STAFF REPORT FOR THE PLANNING COMMISSION

FILE NUMBER: DR-13-01/WAP-13-01/VAR-13-01/VAR-13-02/VAR-13-03/VAR-13-04/MISC-13-01

REQUEST: Class II Design Review, Water Resource Area approval, approval to Expand/Alter a Non-Conforming Structure, and four Class II Variances for construction of a parking lot for the West Linn Public Library and a new path between the parking lot and library, at 1595 Burns Street and 5750 Hood Street.

Excerpt of Map 17, Landslide Vulnerability Analysis, Page 52, West Linn Natural Hazards Mitigation Plan. Light pink represents landslide vulnerability areas.

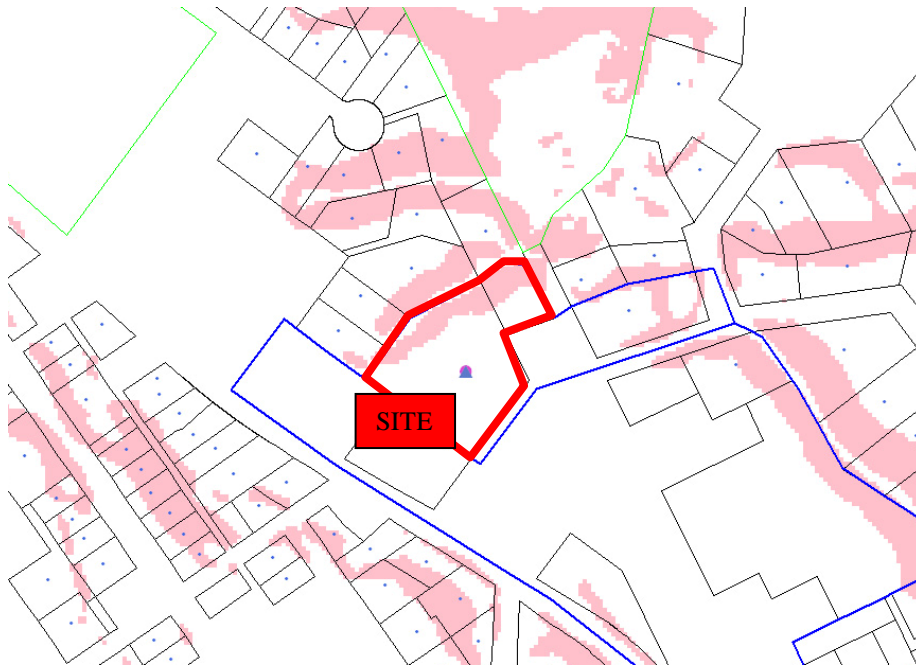
Staff Response 131: The most updated material related to the criterion is in the City's Natural Hazards Mitigation Plan. Map 16, Potential Landslides, in this plan shows the Oregon Department of Geology and Mineral Information (DOGAMI) potential landslide areas, none of which are on this site. Map 17 Landslide Vulnerability Analysis shows landslide hazard areas in the City. City GIS staff was able to provide a blow-up version of this map, which is included below, so the landslide hazard areas on the small site could be seen better than on the city-wide scale in the Natural Hazards Mitigation Plan. The only proposed structures are the retaining walls along the parking area and just north of the west end of the parking lot and adjacent path. The landslide hazard areas (shown in pink on the following map) are all within the northern half of the Hood Street parcel, and adjacent areas of the Burns Street parcel to the west. The proposed development including the walls is all within the southern half of the Hood Street parcel and adjacent areas of the Burns Street parcel to the west. Therefore there

is no overlap between the landslide hazard areas and the areas proposed for development of structures, so staff finds and determines that the criterion is met.

Figure 14: Mitigation plan with specific location

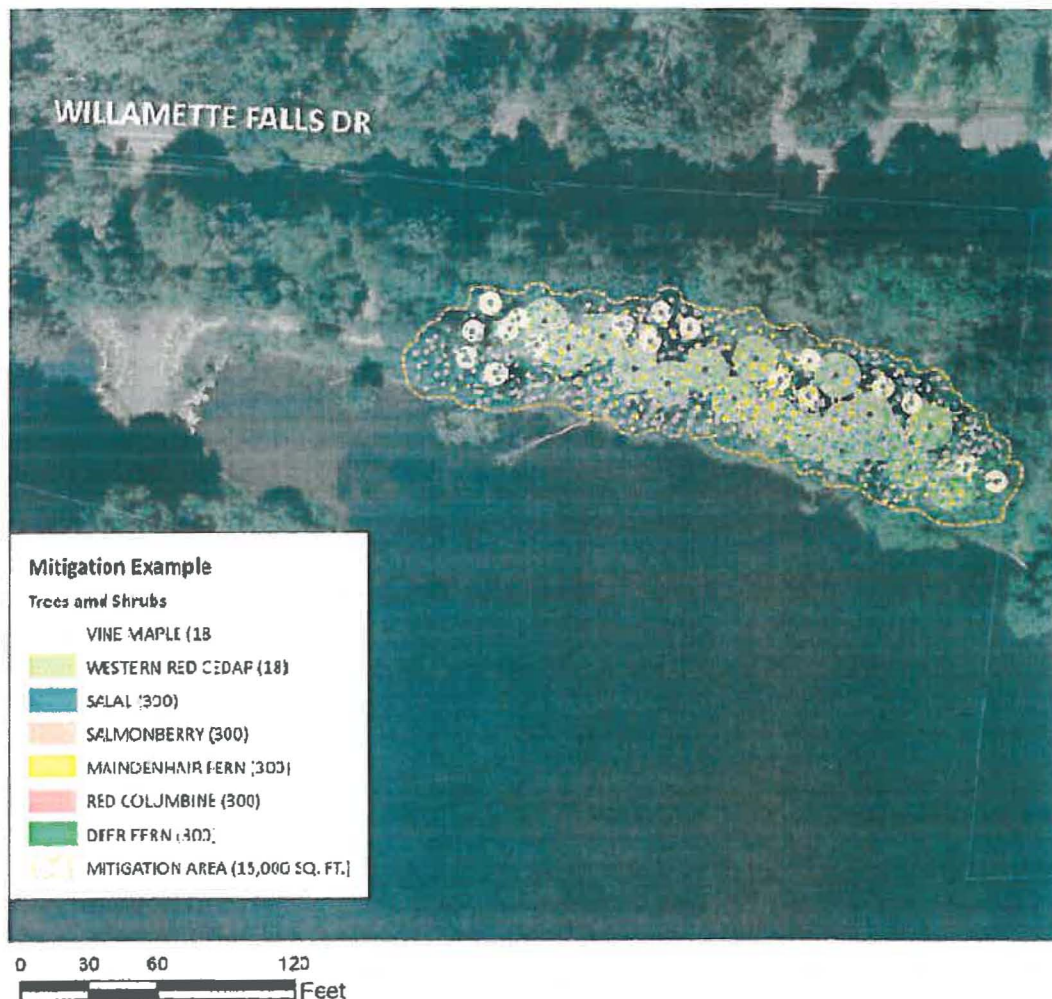
(Correction: Mitigation area in legend should read "6,013 square feet")

Figure 17: Parking Lot Landscape Plan

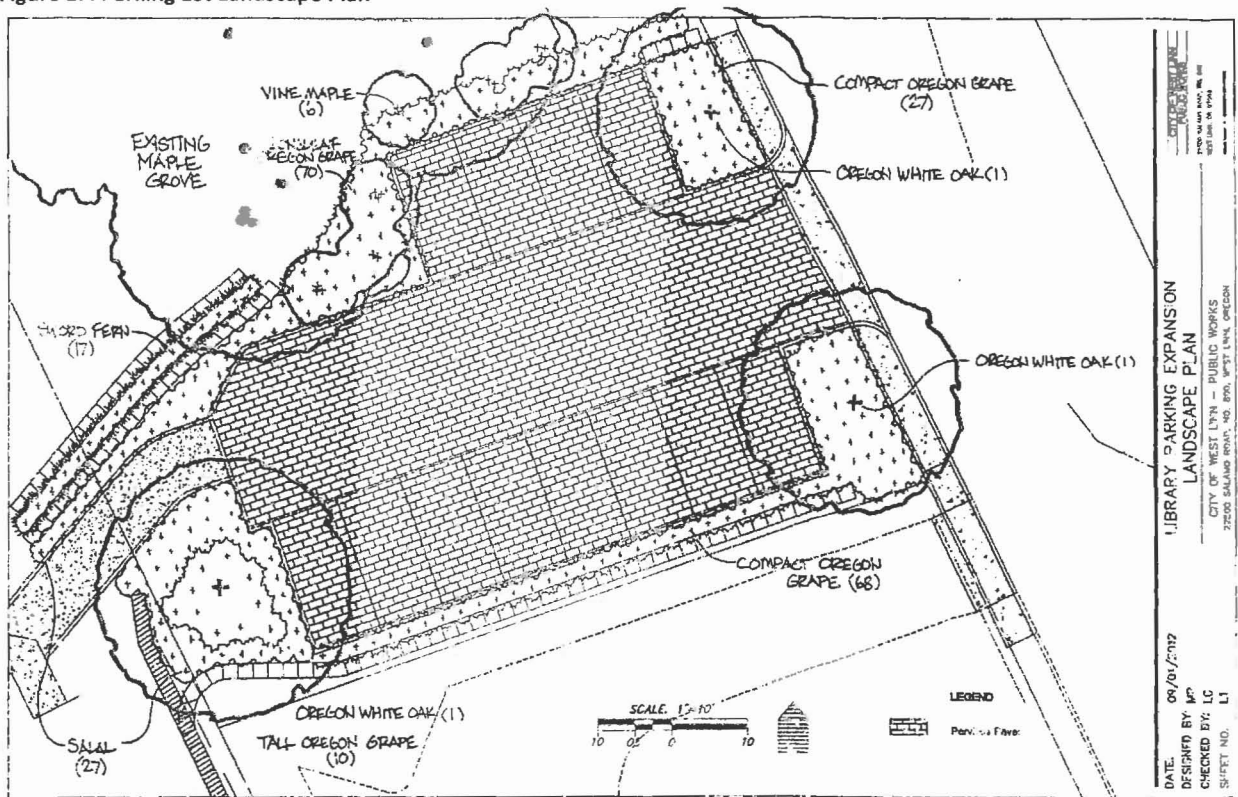
8. Revegetation Plan Tree and Plant Sizing and Spacing.
 - a. In addition to the vine maples proposed on the Landscape Plan, another type of native tree, acceptable to the City Arborist, shall be planted midway between the two vine maples that are furthest apart on the landscape plan.

Figure 33: Photometric drawing with proposed light locations shown

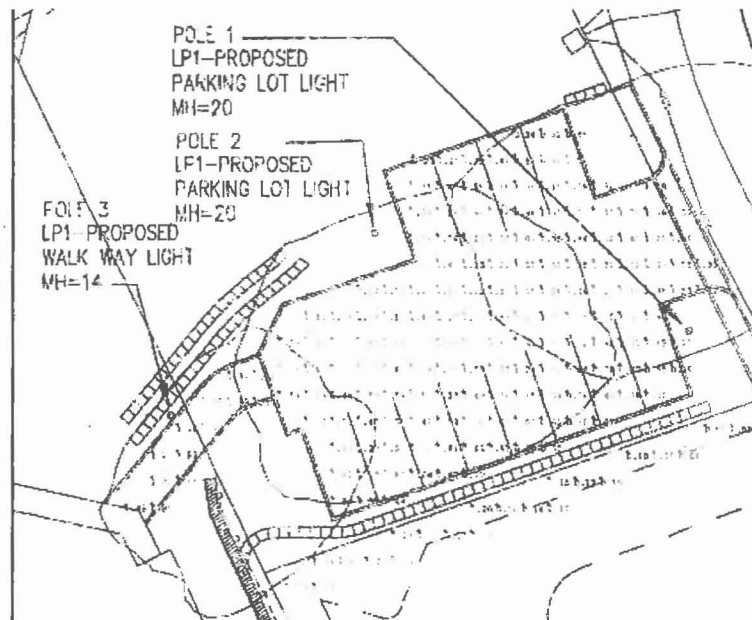
The parking lot is proposed to be lit and will be visible from the library building. Parking lot lighting design and location is proposed in the lighting plan, Sheet EL1, on Page 172 of Exhibit PC-4. Proposed Condition of Approval 7 ensures lighting will be deflected to only shine in the area of the development, and also ensures that lighting will cover the proposed path to the library and not just the parking lot and driveway. Much of it will also be visible from Hood Street through the driveway entrance and its adjacent required clear vision areas. This helps ensure line of sight in and out of the site as well.
